ADC Telecommunications		A0	20028104	5/17/99	LRT
		REV	ECO	DATE	APV
APV	TITLE SCH, SINGLE STAG AMPLIFIER ASSY, CLASS A, LOW BAND (1265-1418)				
DATE					
REV	MATERIAL				
ECO	FINISH				
REV	DWN				
ECO	CHK				
REV	REL				
ECO	JAG				
REV	JAG				
ECO	3/20/96				
REV	C				
ECO	SCALE ---				
REV	SHEET 1 OF 1				
ECO	REV				
REV	A0

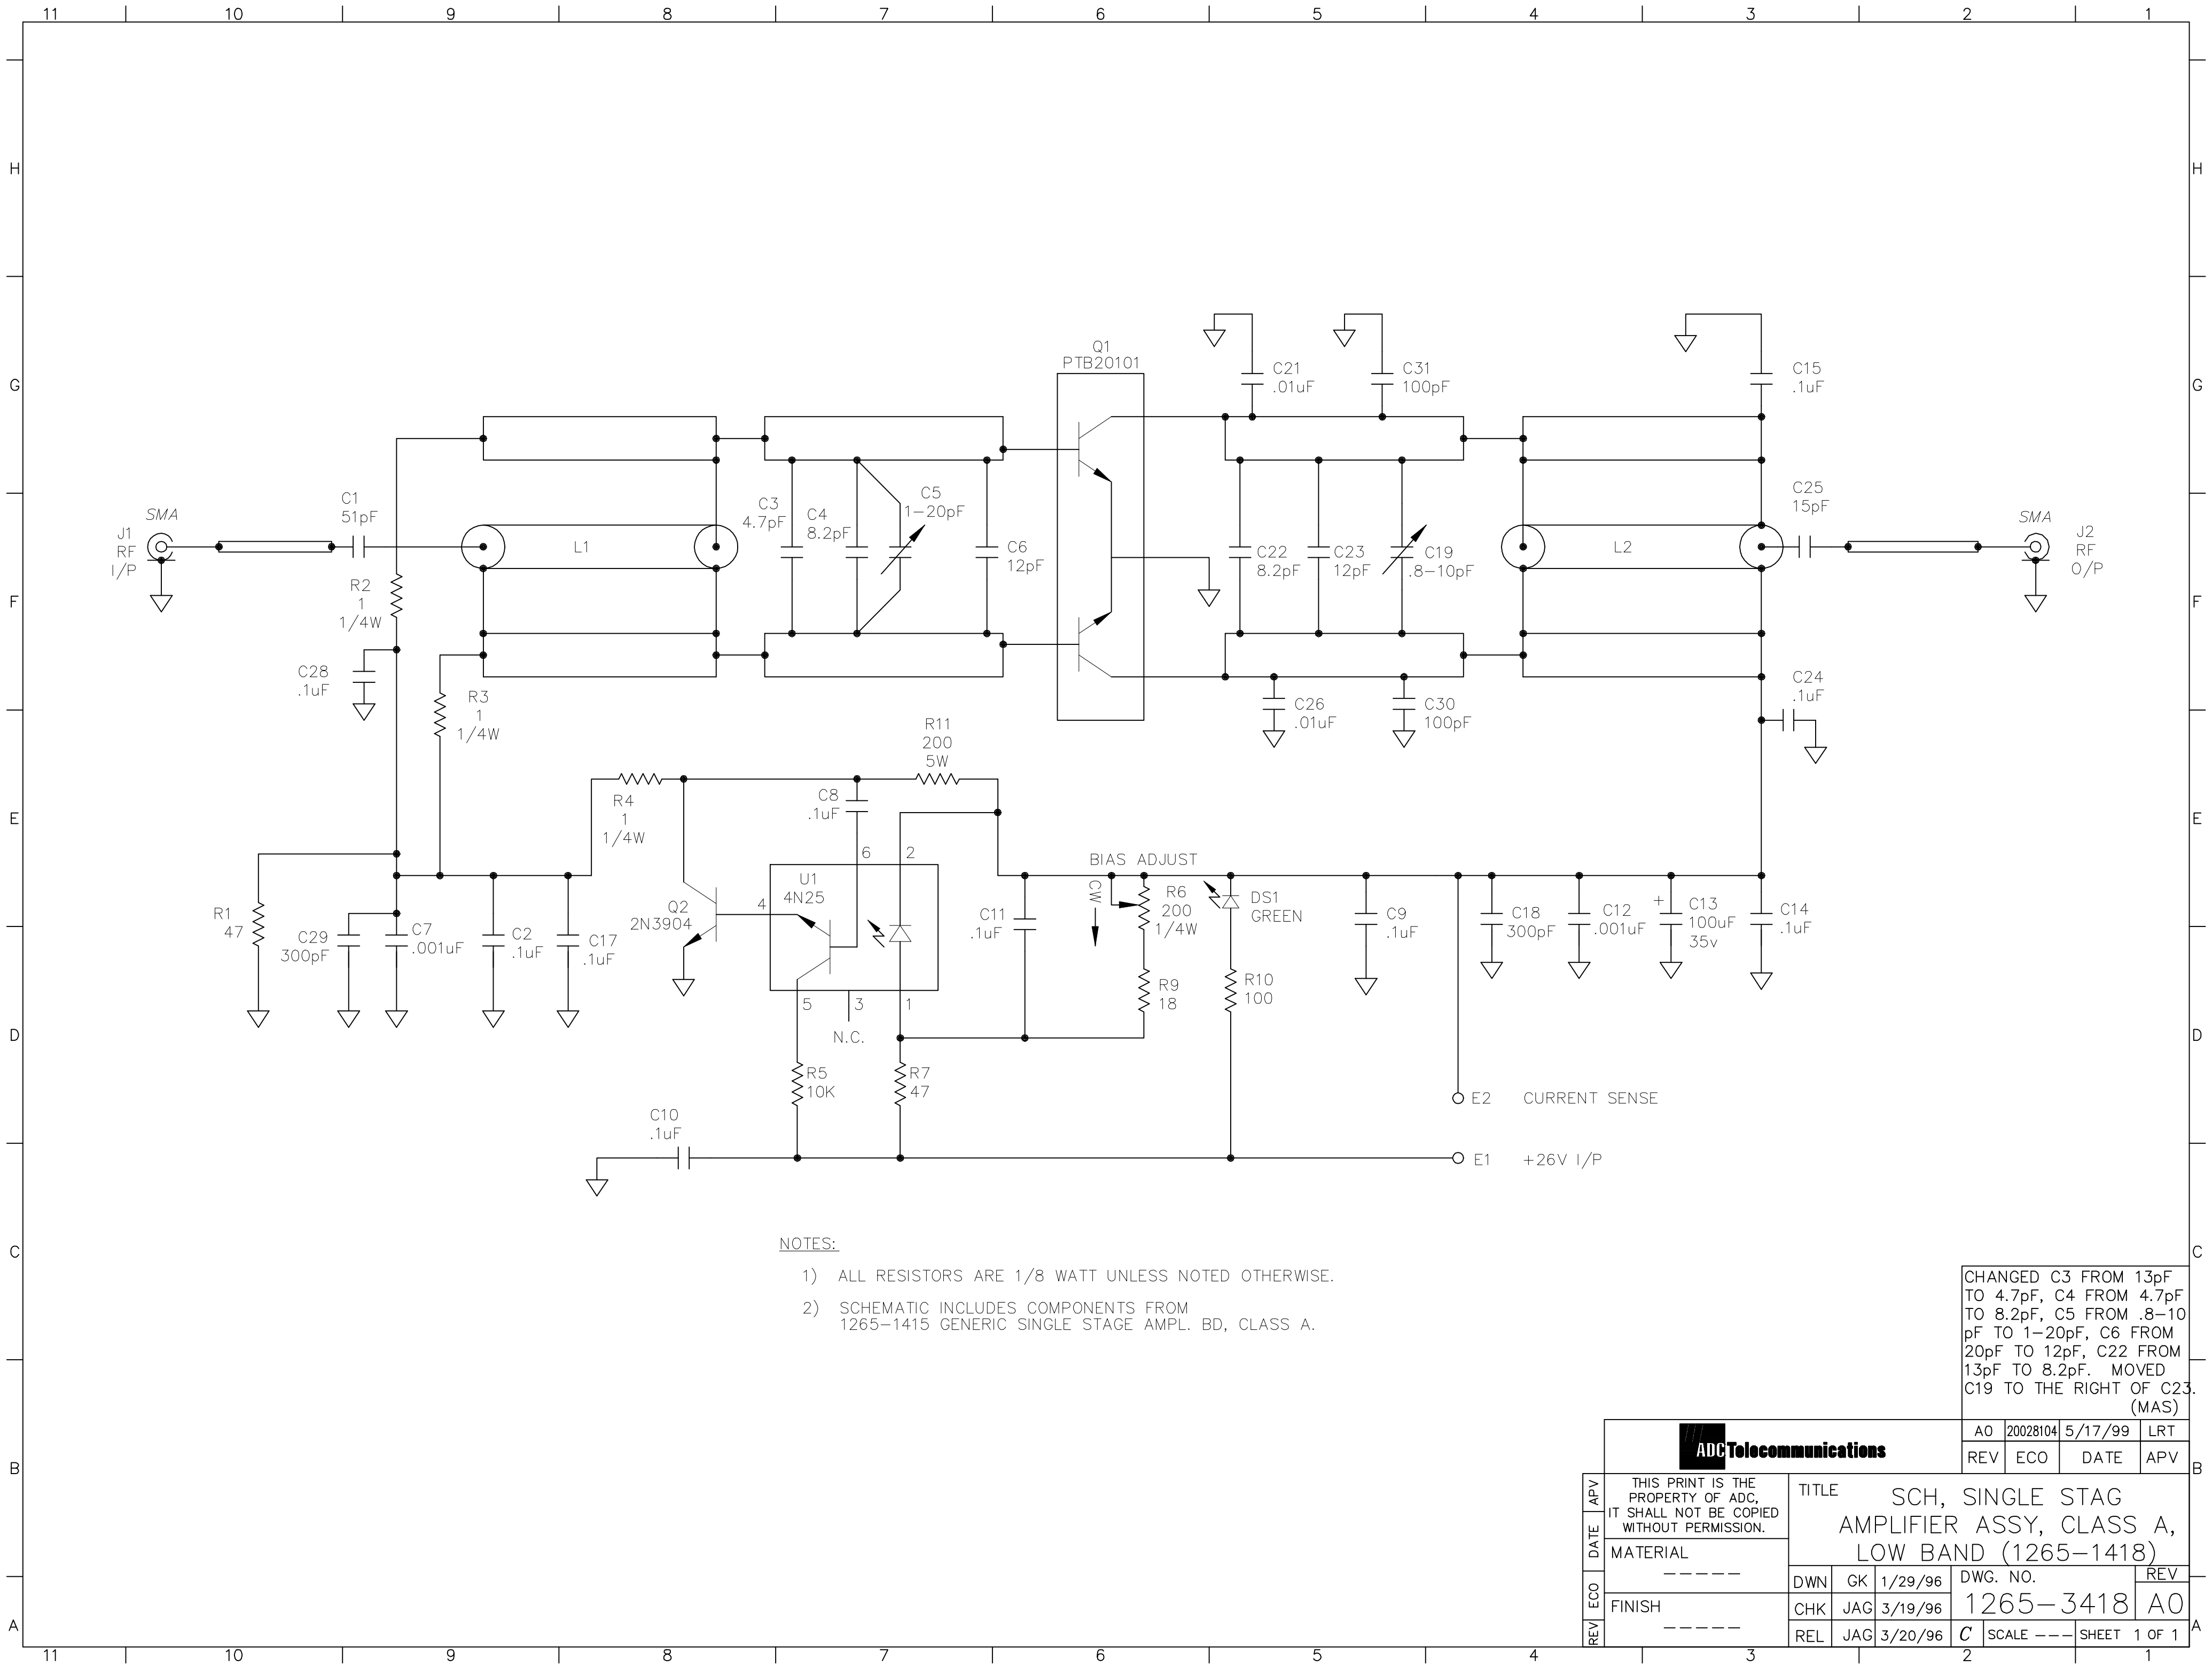
CHANGED C3 FROM 13pF TO 4.7pF, C4 FROM 4.7pF TO 8.2pF, C5 FROM .8-10 pF TO 1-20pF, C6 FROM 20pF TO 12pF, C22 FROM 13pF TO 8.2pF. MOVED C19 TO THE RIGHT OF C23. (MAS)
